Access Compliance Report

Public Rights-of-Way

(Curb Ramps)

Intersection ID: 17660	Main Street: MURRAYHILL_RD	Cross Street: NORTHGATE_AV	Location: SW
ADA ID: 42E1065F1FBC	Ramp Type: PerpDiag	Initial Pass/Fail: Fail	Overall Compliance: No
Severity Score: 33.75			
Codes/Mitigation Info/Possible Solution		Field Measurements/Component Compliance

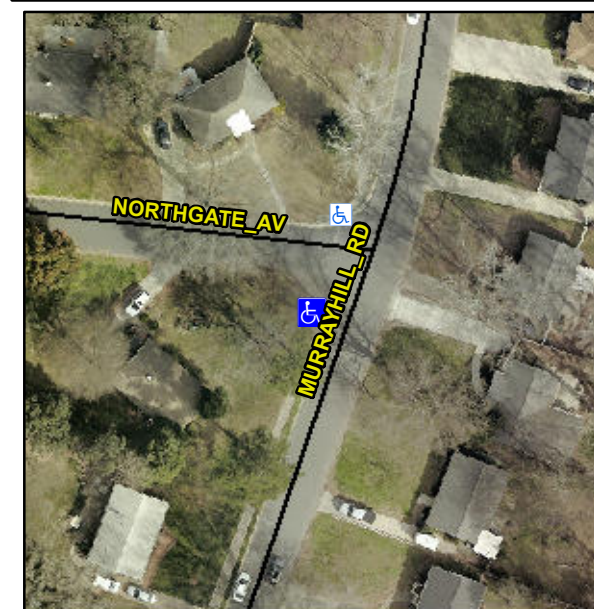
PROW/ADA:

Not Found, R304.5.1, R304.5.3

Compliance	Description	Data	Compliance	Description	Data
N/A	Ramp Length (in)	59.0	Yes	Ramp Slope (%)	6.8
No	Ramp Width (in)	38.5	No	Ramp XSlope (%)	7.0
N/A	Flare Type LT	N/A	N/A	Flare Type RT	N/A
N/A	Flare Slope LT (%)	N/A	N/A	Flare Slope RT (%)	N/A
N/A	Flare Traversable LT?	N/A	N/A	Flare Traversable RT?	N/A
N/A	Landing Length (in)	N/A	N/A	DWS Provided?	N/A
N/A	Landing Width (in)	N/A	N/A	DWS Contrast?	N/A
N/A	Landing Slope (%)	N/A	N/A	DWS Length (in)	N/A
N/A	Landing X Slope (%)	N/A	N/A	DWS Full Width?	N/A
N/A	Landing Curb? (Y/N)	N/A	N/A	DWS Offset (in)	N/A
N/A	Shared Landing?	N/A			
N/A	Gutter Ponding?	N/A	N/A	Gutter Slope (%)	N/A
N/A	Gutter Lip Ht (in)	N/A	N/A	Gutter X Slope (%)	N/A
N/A	Painted X Walk1?	No	N/A	Painted X Walk2?	No
	X Walk 1 Direction	To E		X Walk 2 Direction	To NE
N/A	X Walk 1 Width (in)	N/A	N/A	X Walk 2 Width (in)	N/A
	X Walk 1 Slope (%)	6.6		X Walk 2 Slope (%)	0.6
	X Walk 1 X Slope (%)	2.9		X Walk 2 X Slope (%)	3.4

Remove & Replace Curb Ramp With Two New Directional Ramps or Equivalent.
